III. REMARKS

This invention generally relates to multi-polarization active array transmit antennas. In particular, the application describes a chip comprising phase shifters that control the scan angle, linear polarization, and circular polarization of an RF signal.

Graphic 1: GaAs Transmit Chip Disclosed in Application Figure 1

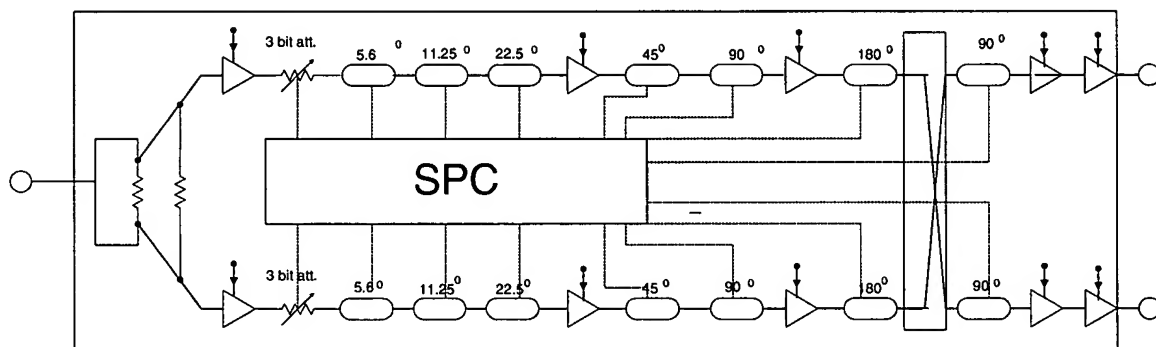
The Examiner rejected of claims 1-10, 22-32 and 34-38 under 35 U.S.C. §112, first paragraph, as failing to comply with enablement requirement because “the specification

fails to sufficiently disclose to a skilled artisan how the attenuator controls the scan angle and/or the linear polarization.” Office Action, p. 2.

Attenuator control of linear polarization can be readily deduced from the specification by a skilled artisan. As shown in Graphic 1 below (modeled on Figure 1 of the specification), signals are output from attenuators 304 and phase shifters 305-310 into Lange Coupler 312.

where V_1 and V_2 are the amplitudes of the corresponding input signals, ω is the angular frequency, t is time, and Φ is the phase difference between the two inputs. By definition, attenuators 304 can attenuate the voltage of a signal and therefore can affect (e.g., attenuate) input voltages V_{in1} and V_{in2} . Also by definition, phase shifters 305-310 can control the phase difference between the two input signals.

The above formula (Equation I) shows that the linear polarization angle, Θ , is a function of V_1 , V_2 , and Φ . A change in any of V_1 , V_2 , and Φ would change the scan angle. Figure 1 shows that V_1 and V_2 can be controlled and adjusted by two attenuators 304 independently, and Φ can be controlled and adjusted by the phase shifters 305-310. By modifying V_{o1} , V_{o2} , and Φ , both attenuators 304 and phase shifters 305-310 can be used to control the linear polarization angle. As noted above, this would be readily apparent to a person skilled in the art of active transmit array antennas.

Graphic 2: Principals of Linear Polarization

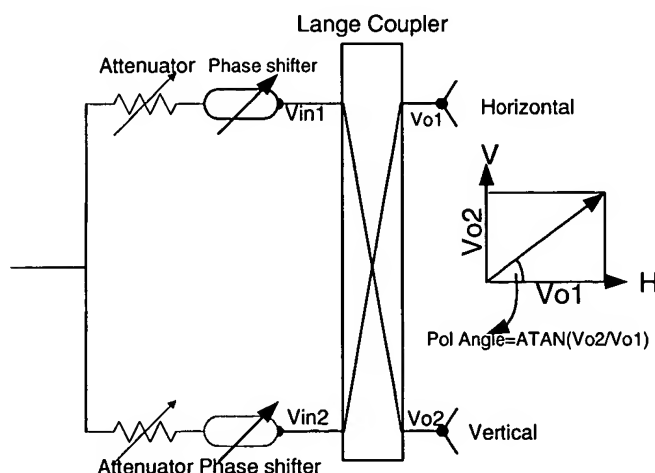
The Examiner rejected claims 1-10, 22-32 and 34-38 under 35 U.S.C. § 112, second paragraph, as being indefinite for failing to particularly point out and distinctly claim the subject matter which applicant regards as the invention. The Examiner requests that the Applicant show “how the attenuator provides each of the scanning control and linear polarization control.”

There is a 90 degree phase shifter between the output ports of the Lange coupler 312. According to basic electronic signal theory, the amplitude of the Lange coupler's 312 output signal (into phase shifters 3092) depends on the phase difference between the two input signals (from phase shifter 310). A skilled artisan would readily deduce that the output voltages V_{o1} and V_{o2} of the Lange coupler 312 are governed by the following functions:

$$\Theta = \text{ATAN} [(V_2 \cos (\Phi)) / (V_1 - V_2 \sin (\Phi))] \quad \text{[Equation I]}$$
